Access Compliance Report

Public Rights-of-Way

Intersection ID: 50485	Main Street: JONES_CROSSING_RD	Cross Street: HAWFIELD_WAY_DR	Location: SE
ADA ID: 060C5DF78AFB	Ramp Type: Perp	Initial Pass/Fail: Fail	Overall Compliance: No
Codes/Mitigation Info/Possible Solution			Severity Score: 10
			Field Measurements/Component Compliance

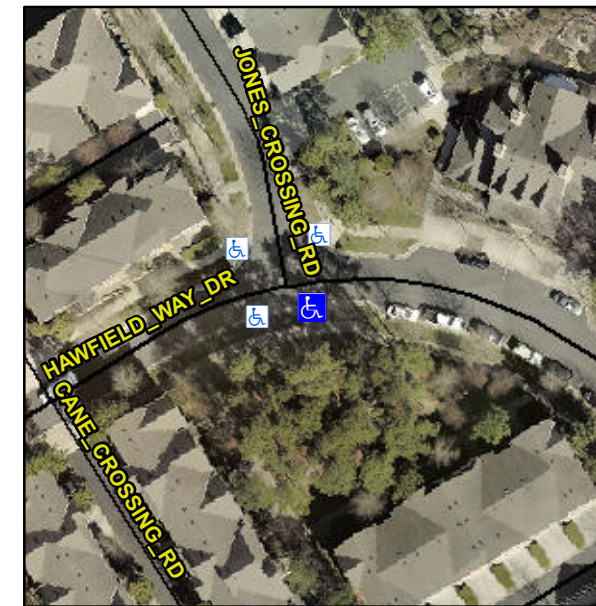
Not Found, R304.5.1

Compliance	Description	Data	Compliance	Description	Data
N/A	Ramp Length (in)	94.5	Yes	Ramp Slope (%)	8.0
No	Ramp Width (in)	47.0	Yes	Ramp XSlope (%)	4.2
N/A	Flare Type LT	N/A	N/A	Flare Type RT	N/A
N/A	Flare Slope LT (%)	N/A	N/A	Flare Slope RT (%)	N/A
N/A	Flare Traversable LT?	N/A	N/A	Flare Traversable RT?	N/A
N/A	Landing Length (in)	N/A	N/A	DWS Provided?	N/A
N/A	Landing Width (in)	N/A	N/A	DWS Contrast?	N/A
N/A	Landing Slope (%)	N/A	N/A	DWS Length (in)	N/A
N/A	Landing X Slope (%)	N/A	N/A	DWS Full Width?	N/A
N/A	Landing Curb? (Y/N)	N/A	N/A	DWS Offset (in)	N/A
N/A	Shared Landing?	N/A			
N/A	Gutter Ponding?	N/A	N/A	Gutter Slope (%)	N/A
N/A	Gutter Lip Ht (in)	N/A	N/A	Gutter X Slope (%)	N/A
N/A	Painted X Walk1?	No	N/A	Painted X Walk2?	N/A
	X Walk 1 Direction	To N		X Walk 2 Direction	N/A
N/A	X Walk 1 Width (in)	N/A	N/A	X Walk 2 Width (in)	N/A
	X Walk 1 Slope (%)	1.5		X Walk 2 Slope (%)	N/A
	X Walk 1 X Slope (%)	4.7		X Walk 2 X Slope (%)	N/A

Remove & Replace Entire Ramp.
